Project: Clarks Point and Port Heiden RPSU
Projects Modular Power Plant
Assembly

Addendum No. Two

DRAWING TITLE:
USED OIL BLENDER
25 GALLON HOPPER
FABRICATION

M5.6

4 M5.6
HOPPER RIGHT SIDE ELEVATION
3\"/>

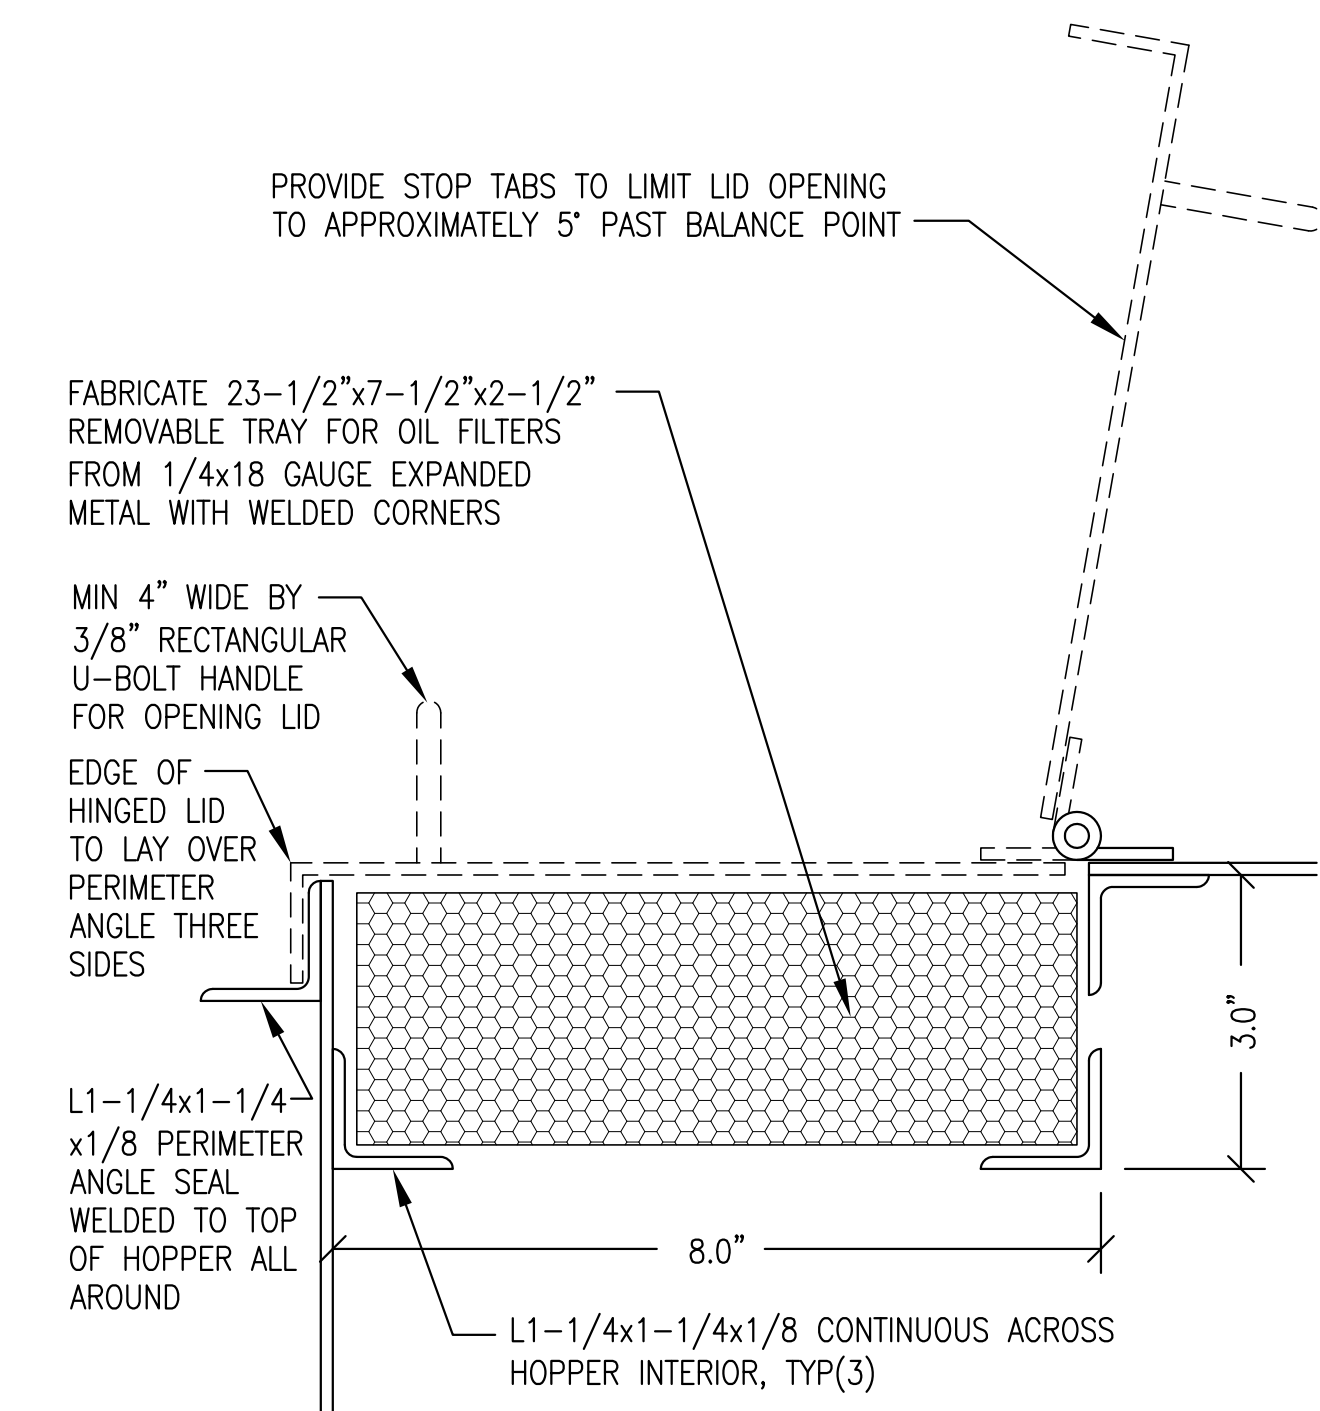
1) **Q:** The drawing index lists **M5.6**, but it is not included in the plan set. Can you please provide this drawing?

A: Please see **Attachment No. 1**.
